Revision	Description	Date
23.10.17		
Mr Gibson		
Meadow View, Well Lane, Gillow Heath Extension & Alterations		
Existing & Proposed Site Plans & Proposed Block Plan		
Drawing Ref: P134 - 205	Rev. B	
Date: 29/09/17	Scale: 1:200	Size: A1
Status: Feasibility	Blog, Regs	Contract
Planning	Tender	Construction

Proposed Site Plan - Ground Floor Plan Level

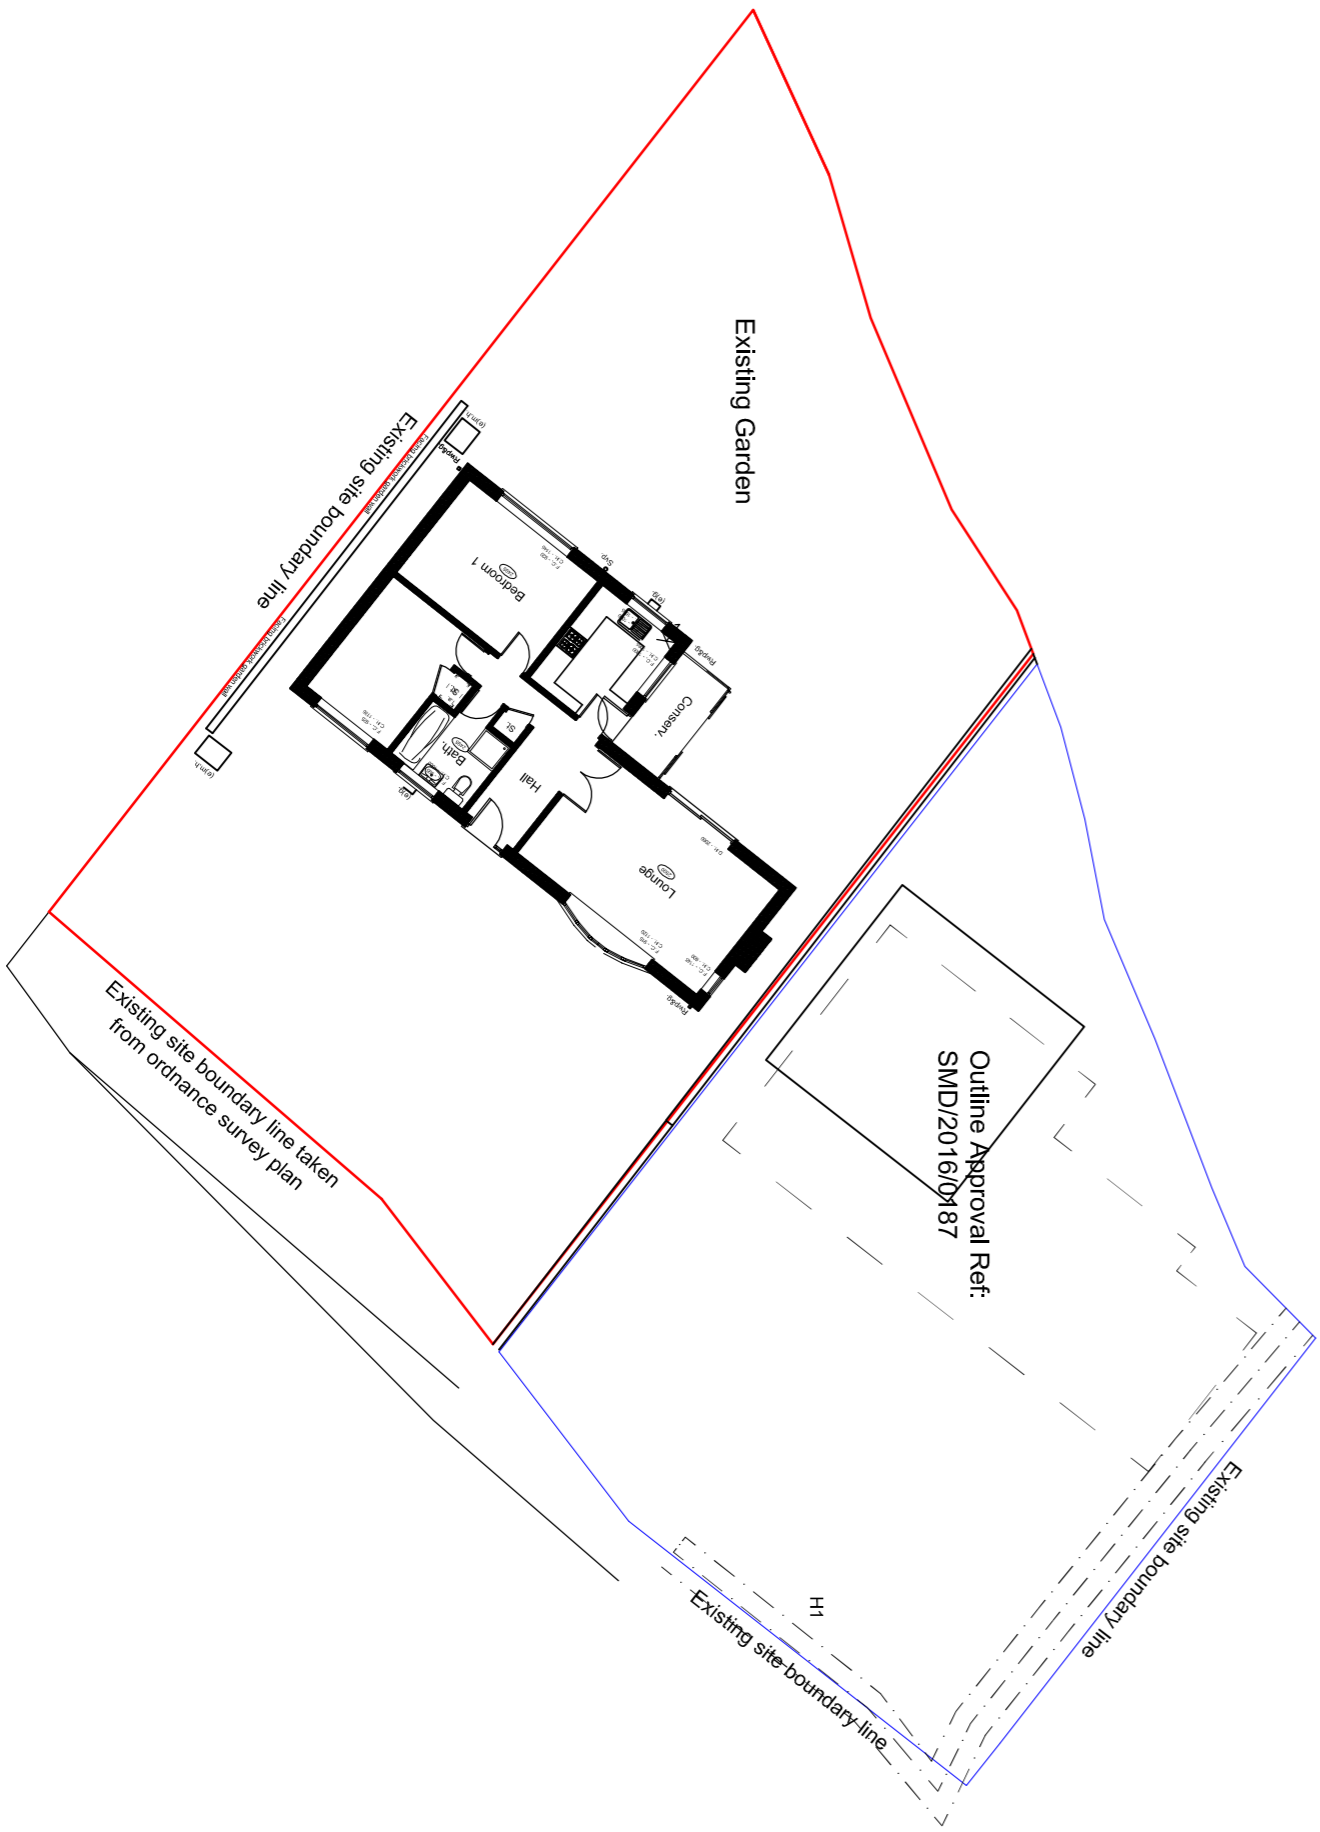
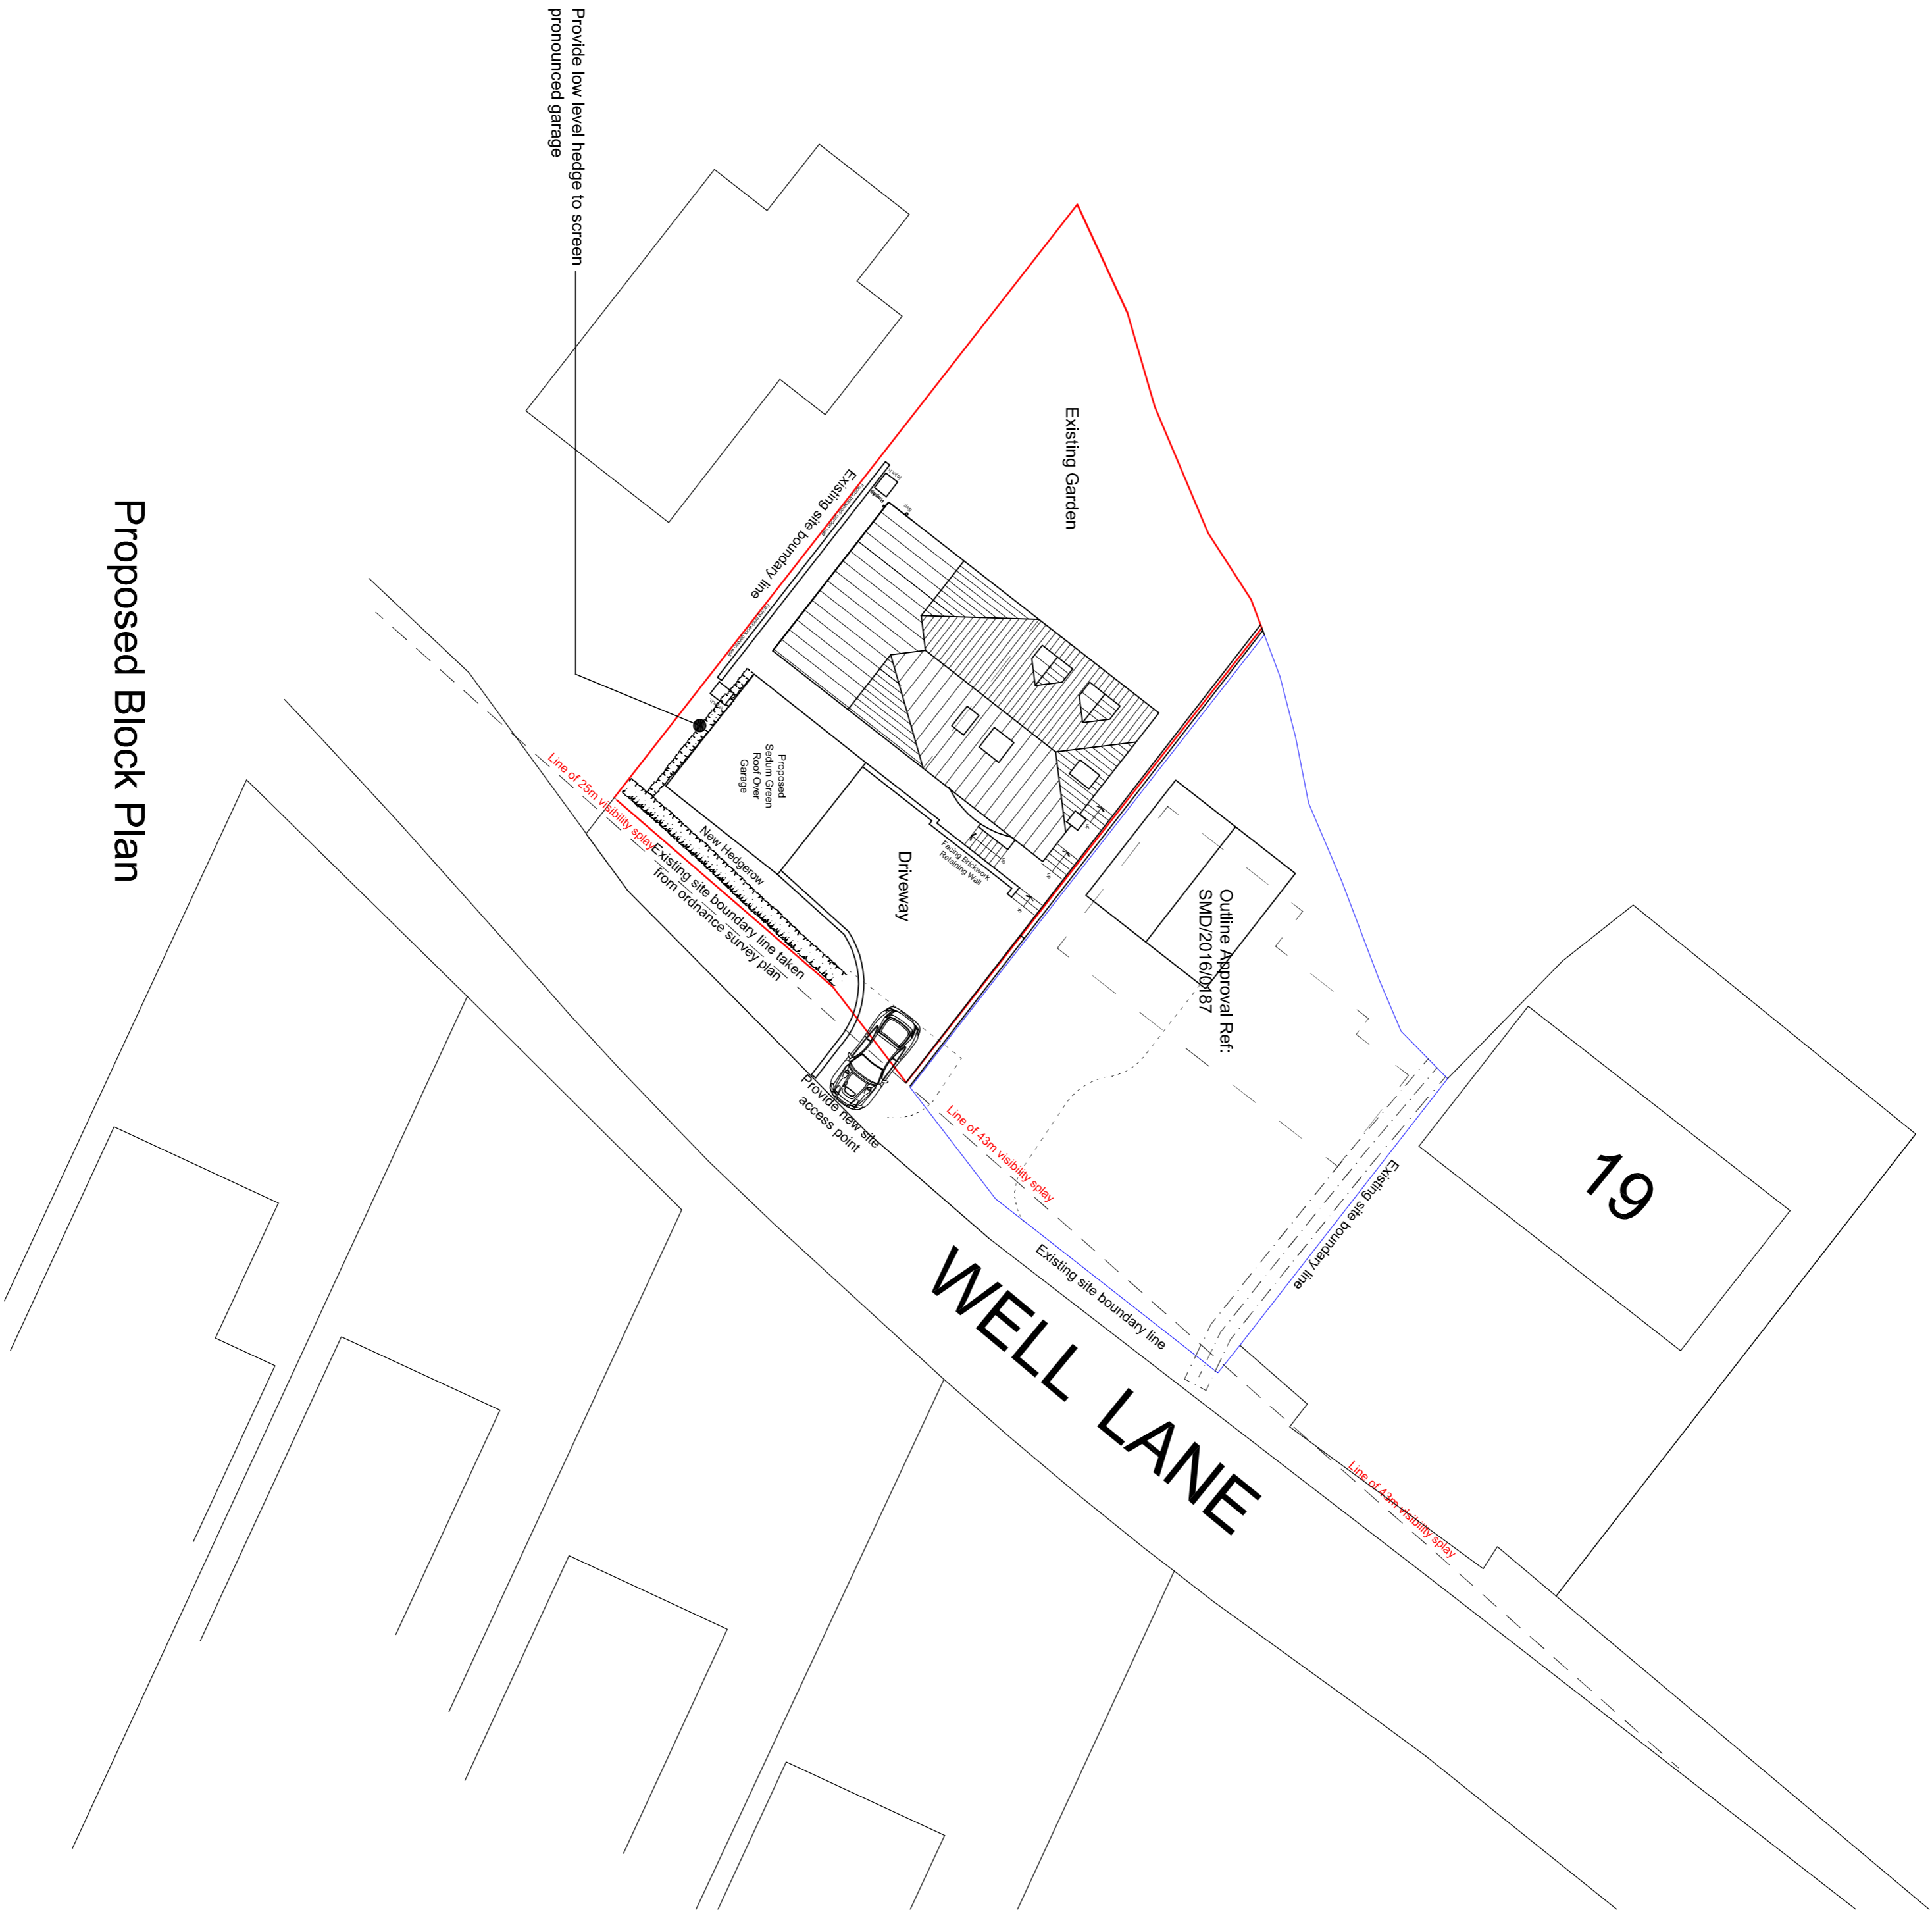
Rev. B. Garage slab level revised to reduce height of extension works further to the local authority's comments.
